# MEMO

Re: Third review for new construction at 143 S. High Street

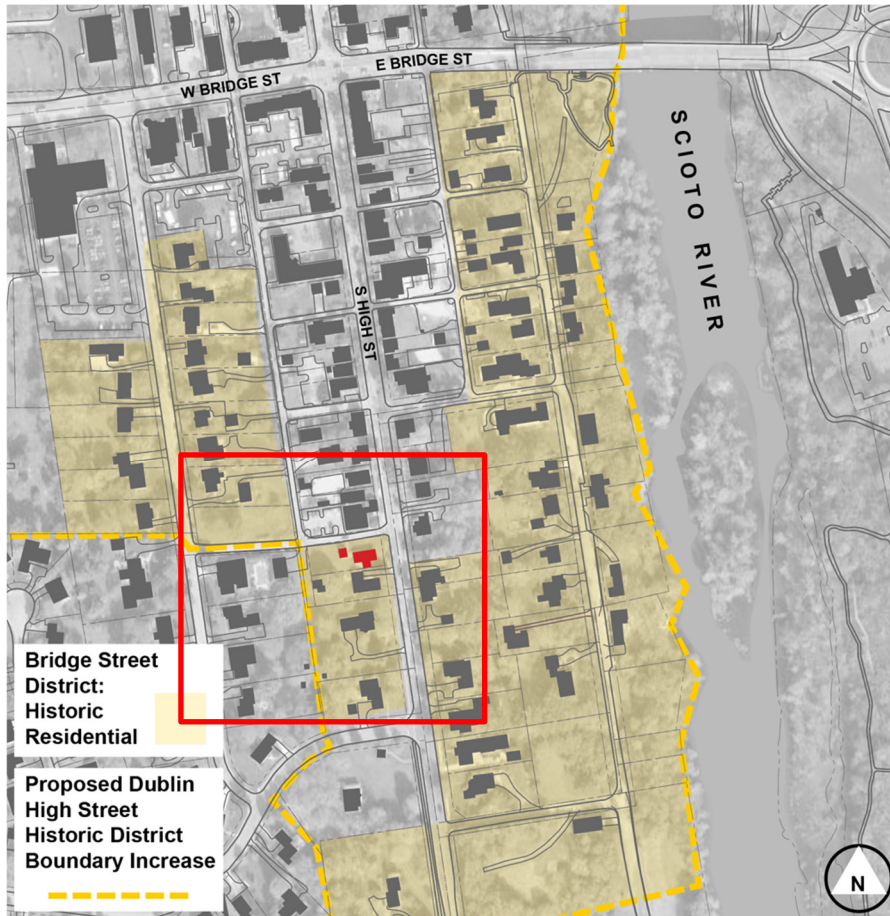
Updated plan of the proposed Schneier Residence at 143 S. High Street by Richard Taylor Architects. Not to Scale. When comparing the proposed plan to the building density illustration (immediately following), the proposed building and features (walks, garage, etc.) take up most of the lot and are out of scale with the neighboring residences.

Updated first floor plan of the proposed Schneier Residence at 143 S. High Street by Richard Taylor Architects.

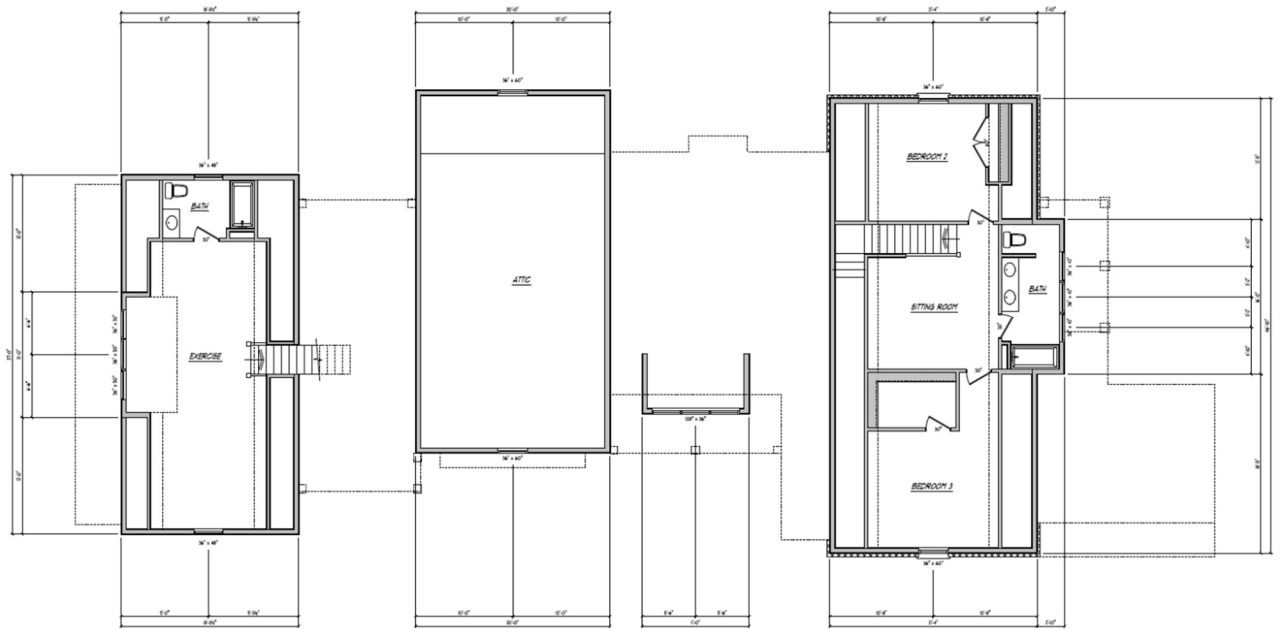
- Provide hidden side elevations, especially along John Wright Lane and S High Street to see how materials wrap around the corners of the building.
- Considered revising the owner's bedroom & porch area to the outdoor living space. The plan and elevation of this area is awkward. It is unclear how these areas intersect and what materials will be used here. See comments under the South elevation.

- The reduced height and mass of garage better suites the site, as does the removal of the chimney towards the eastern end.
- The shingle-sided, shed-roof lean-to at the master bedroom still feels heavy and remains awkward in both plan and elevation. Consider ending the owner's suite along the stone portion of the building and extend the porch along the west side of the owner's suite. Slightly less ideal would be to "enclose" the portion of porch at the master bedroom.

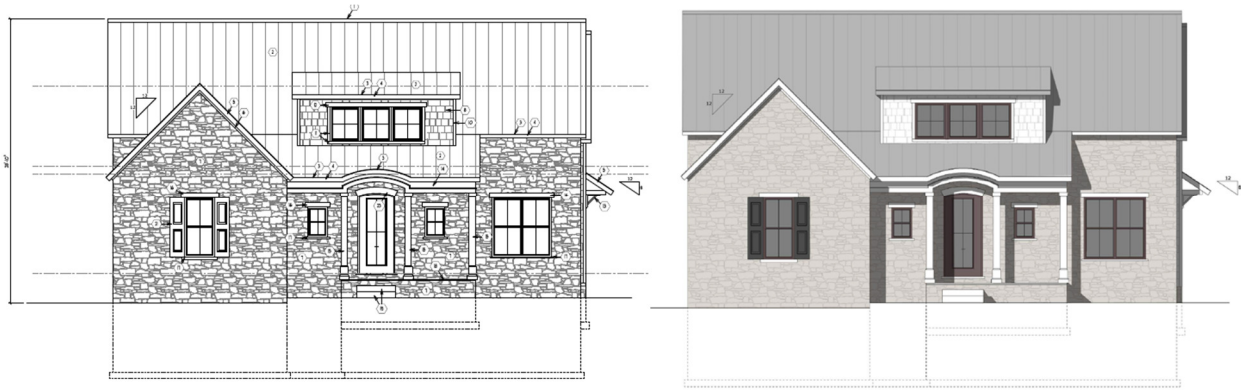
- Consider additional options to reduce the mass and depth of the building along John Wright Ln, including further reducing garage size to two cars with an exterior permeable paver parking space provided for the third car, or excavating the base of the garage so it is below the exterior grade by a couple of feet. Pull the pantry's north wall to the south so it does not protrude beyond the home office's north wall. See additional comments below for the North and West elevations.

- As mentioned above, the front of the building along S. High Street is in keeping with buildings in the area. However, the size and mass of the dwelling along John Wright Lane is still large. Limiting the wood shingles to the area under the eaves and wrapping horizontal siding below would help play down the mass—the previously review’s comment below remains. Also,

eliminating the shed overhang above the pantry window would help lighten this elevation as well as not detract from S High Street facade.

- The materials reflect traditional building materials in the area—stone, standing seam metal roofs, board and batten, and shake shingles. I would consider adding additional horizontal siding to where there is currently large masses of shake shingles. Traditionally, shake shingles would have been used as an accent rather than facing a whole building (unless the building dates to 1880-1900 and is part of the Shingle style predominate in New England). Board and batten, which was commonly used in outbuildings (along with vertical siding) is appropriate for the garage.
- The foundation now matches the chimney with the elimination of the brick finishes.
- The reduced garage now has three separate roof slopes—please reduce to two; ideally all three should match but this may not be possible.

- The empty stone elevation at the owner's master closet and the small window at the master bath feels disjointed; since this part of the south elevation is visible to S High street, the rhythm of the window openings must be minimally hinted at. Because this is a new build, it is possible to break up the elevation by either adding stone lintels, sills and shutters permanently fixed in the closed position with all of the appropriate hardware as if they were operable; or by creating one or two rectangular recesses (2" min.) of stone infill that match the master bedroom's window in height and width. Stone headers and sills would be installed as if this were a true window location

- Review comments above regarding shake shingles versus horizontal siding. I would also add more horizontal siding to this elevation and reduce the use of shake shingles, perhaps isolating the shingles from the bottom of the eaves up, with horizontal siding extending downward to the foundation.

- As mentioned above, lowering the roofline and making the western most portion a lean-to has greatly helped reduce the mass of the building. The shed dormer still feels heavy with the larger windows—pushing the dormer back into the roof would help, perhaps widening the dormer to make up for the loss of space but limiting the dormer height and providing siding between the windows would help.
- Review comments above regarding shake shingles versus horizontal siding. Board and batten, which was commonly used in outbuildings (along with vertical siding) is appropriate for the garage.
